Appendix D:

Public Open House Summaries and Comments

Summary of First Round of Public Open Houses

This document is a summary of the first round of Public Open Houses held as part of the North Druid Hills Road Corridor Study on January 14, 2019 and January 16, 2019. The summary provides an overview of materials presented during the open houses as well as a summary of comments submitted during and after the open houses. Comments were accepted both in paper at each open house and electronically to the study team (NDruidHills@brookhavenga.gov) for a period of nearly two weeks following these open houses, through January 25, 2019.

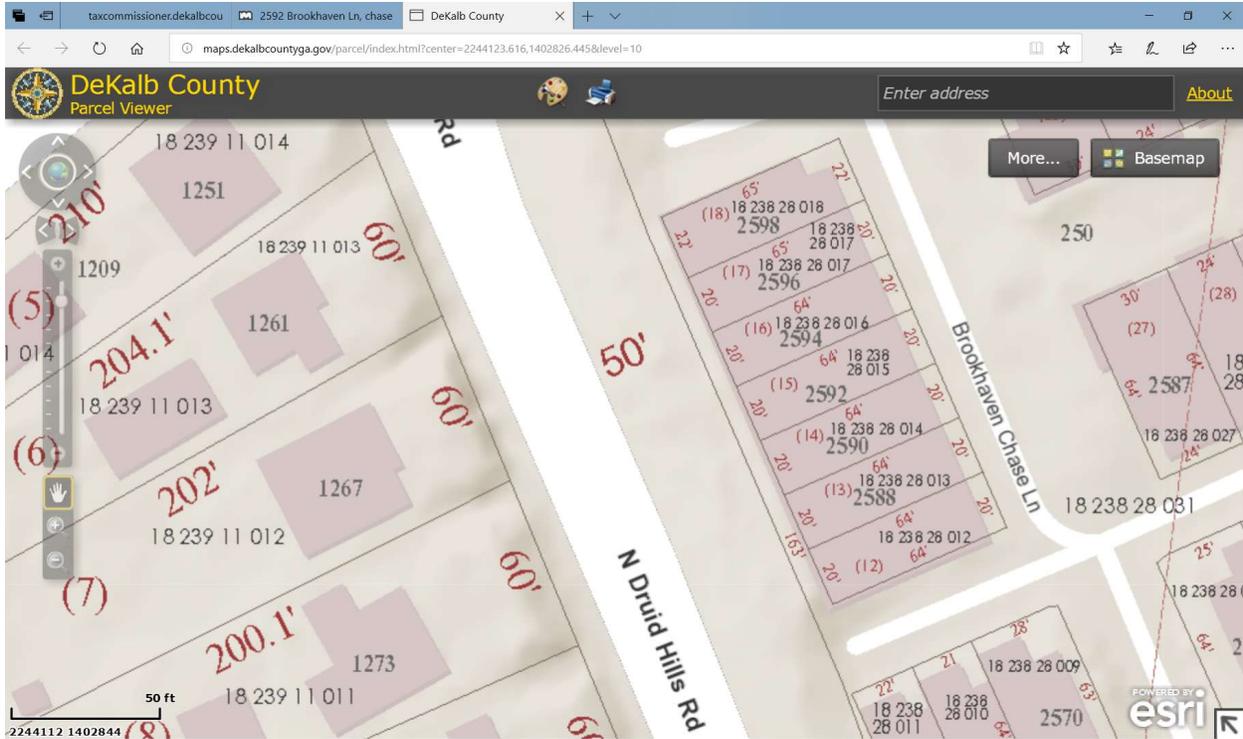
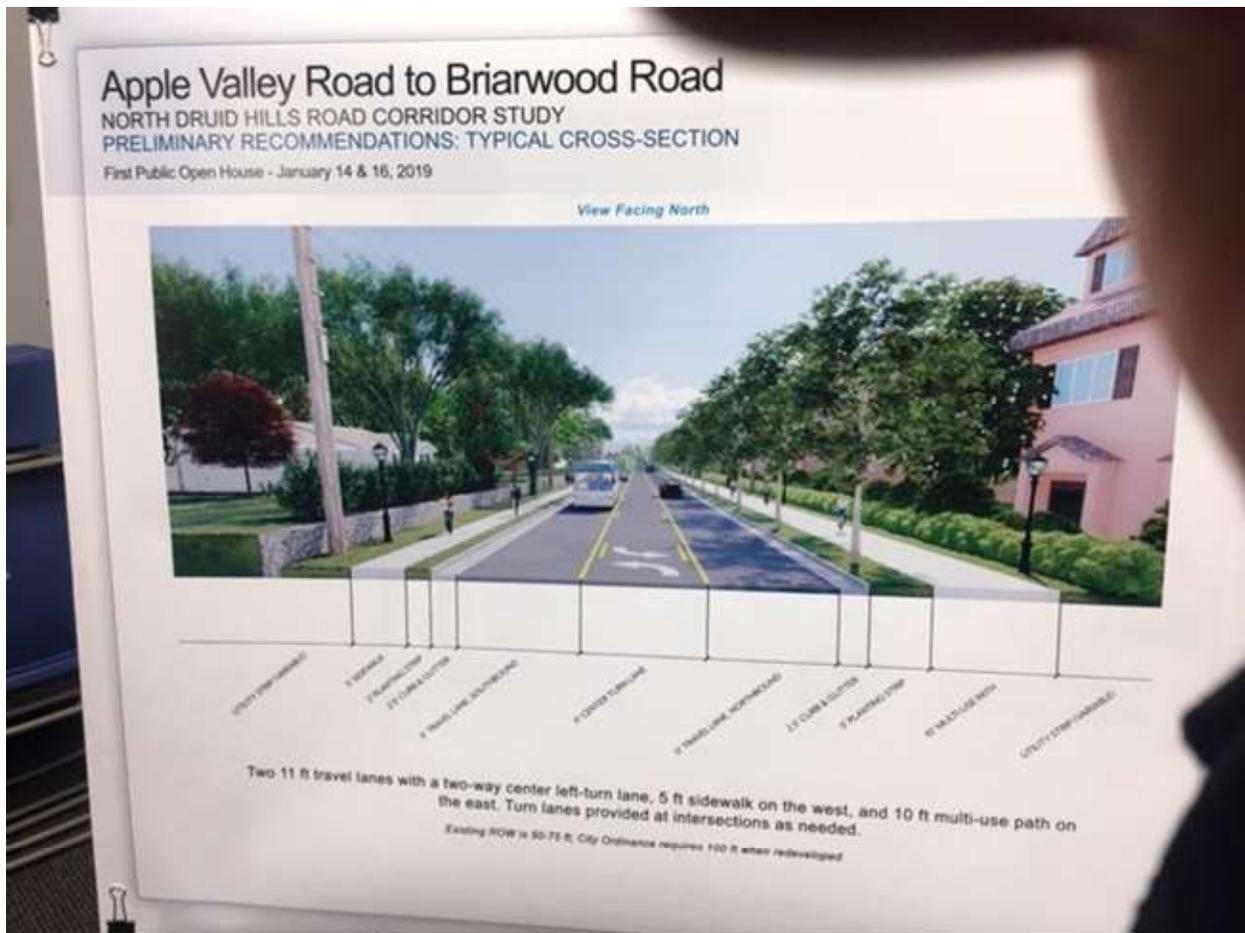
My home is part of the Brookhaven Chase townhome community. As you can see below, it appears that our property line for our community does end at the actual front of our physical homes as indicated in the tax parcel map below. My expectation would be that our side of the road would absorb much of any expansion.

Our homes are very close of North Druid Hills as they currently stand today.

As you can see in the two pics above, there are a few large trees, enclosed by a brick flower bed. Also, the only barrier between our community and North Druid Hills road is a wall that includes brick pillars connected with wrought iron posts.

The 2 photos indicate that we currently lack much frontage or separation between our homes and the street. While not much, we tremendously value this small amount of buffer we currently have. While there is already street noise from the traffic, our small buffer provides us the only help we have.

I understand the task at hand is a difficult one but I would like to suggest you try to reduce the expanded foot print by excluding the bicycle lane or trying to exclude this area for the expansion.

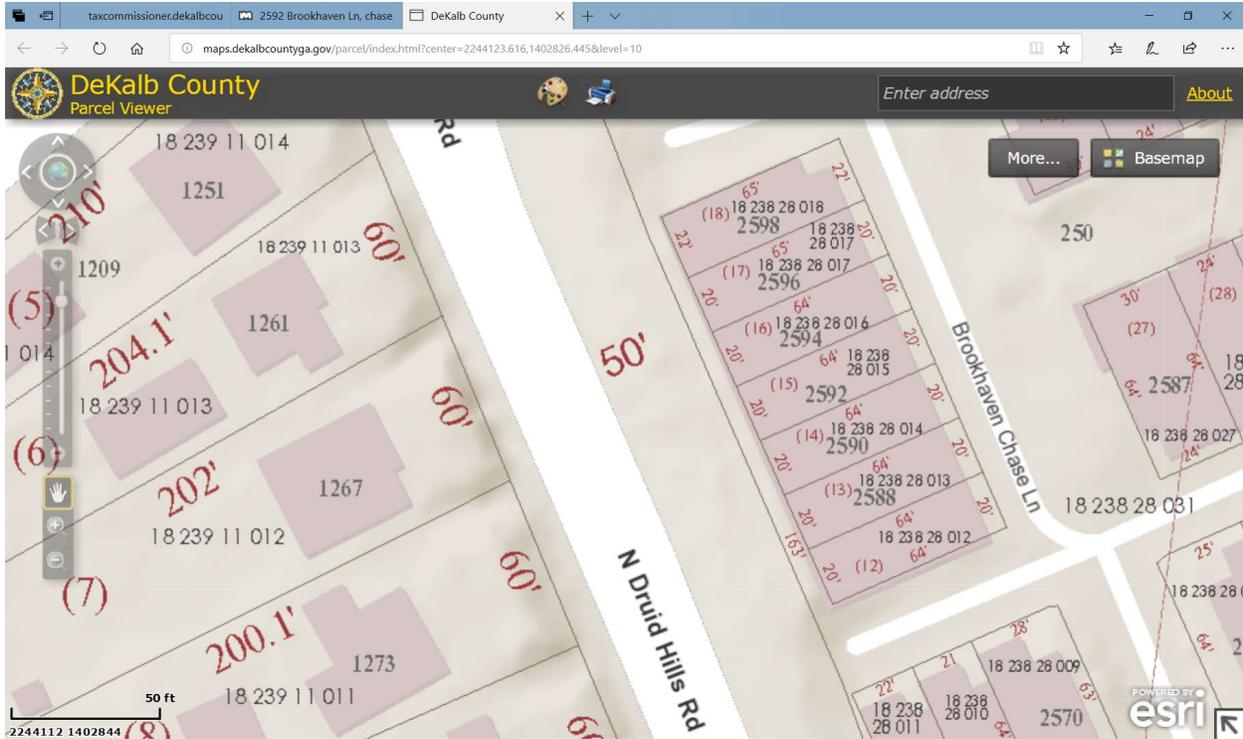
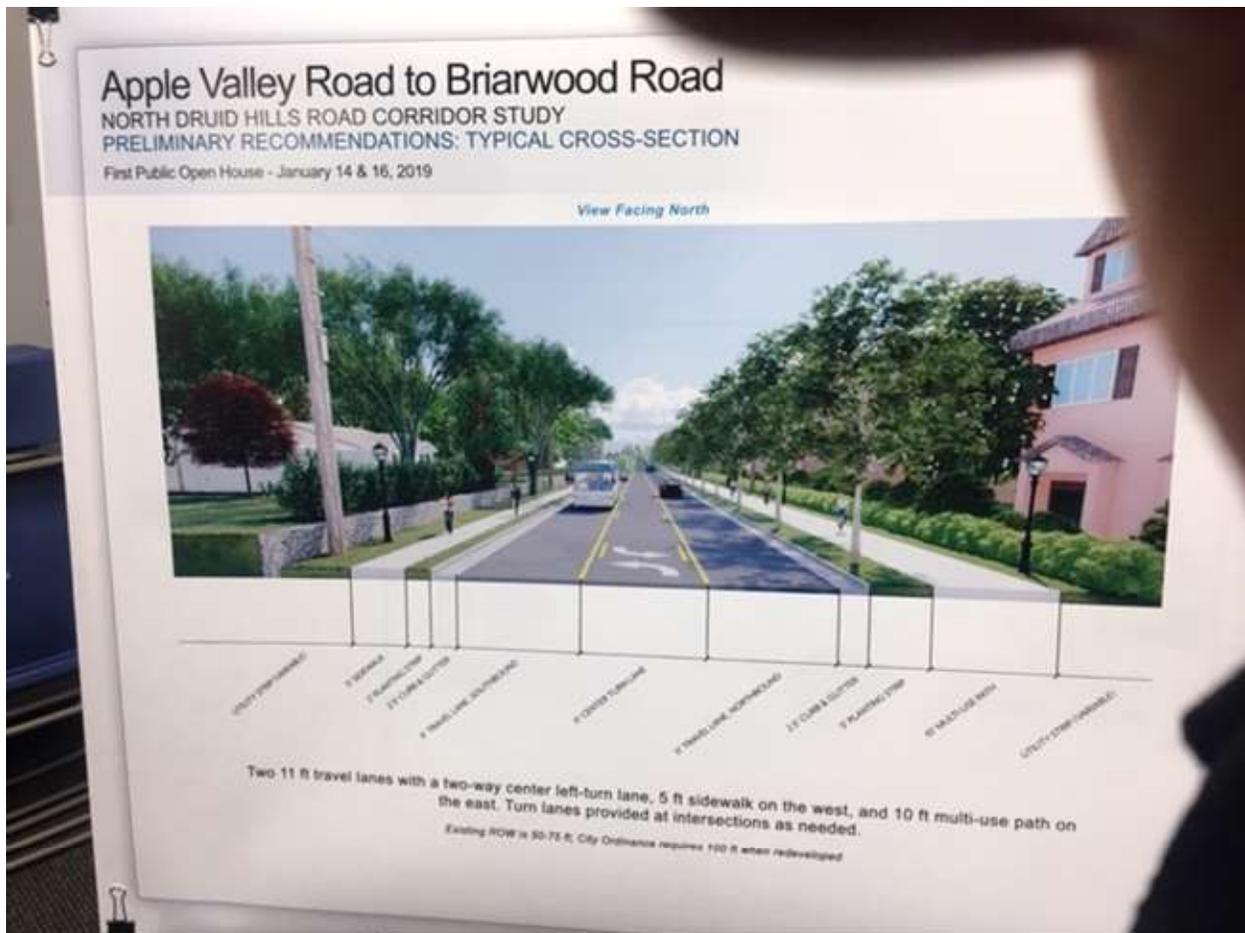
My home is part of the Brookhaven Chase townhome community. As you can see below, it appears that our property line for our community does end at the actual front of our physical homes as indicated in the tax parcel map below. My expectation would be that our side of the road would absorb much of any expansion.

Our homes are very close of North Druid Hills as they currently stand today.

As you can see in the two pics above, there are a few large trees, enclosed by a brick flower bed. Also, the only barrier between our community and North Druid Hills road is a wall that includes brick pillars connected with wrought iron posts.

The 2 photos indicate that we currently lack much frontage or separation between our homes and the street. While not much, we tremendously value this small amount of buffer we currently have. While there is already street noise from the traffic, our small buffer provides us the only help we have.

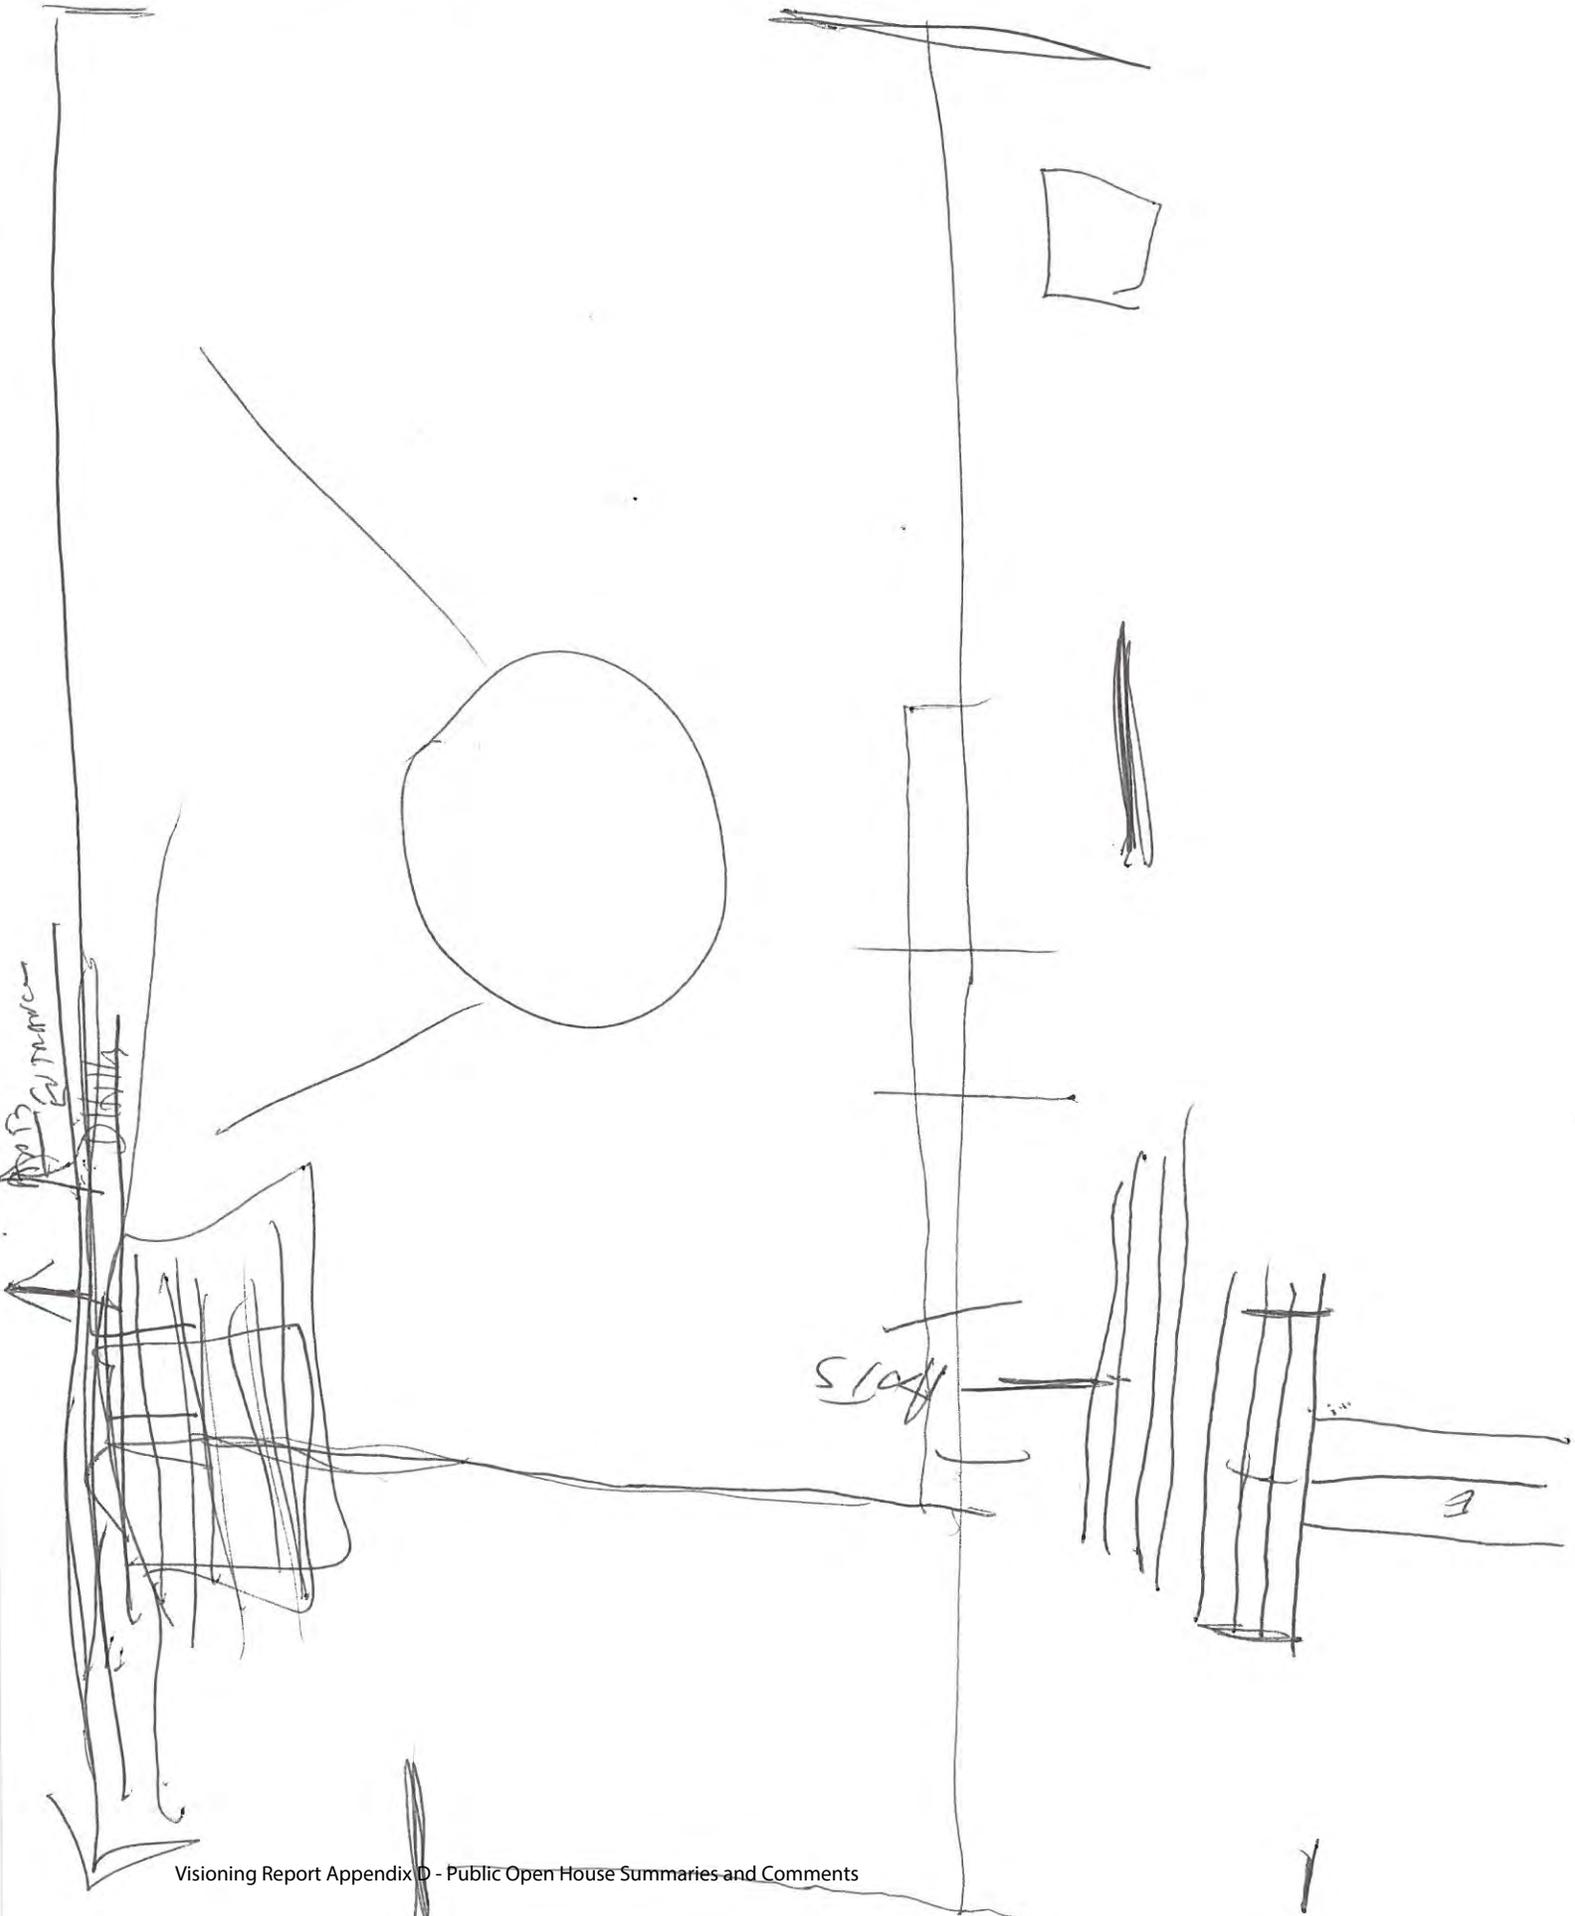
CHILDRENS ~~ADJ. ENTRANCE~~ ADJ. ENTRANCE
BOTH TURN SOME LANE DRUID HILLS MOVE ENTRANCE ADJ.

MANY HEADON COLLISIONS - TURN LANE IS VERY DANGEROUS

ENTRANCE TO ~~ADJ.~~ APARTMENTS - WALL OF LANDSCAPE
MUST MOVE THESE ENTRANCE
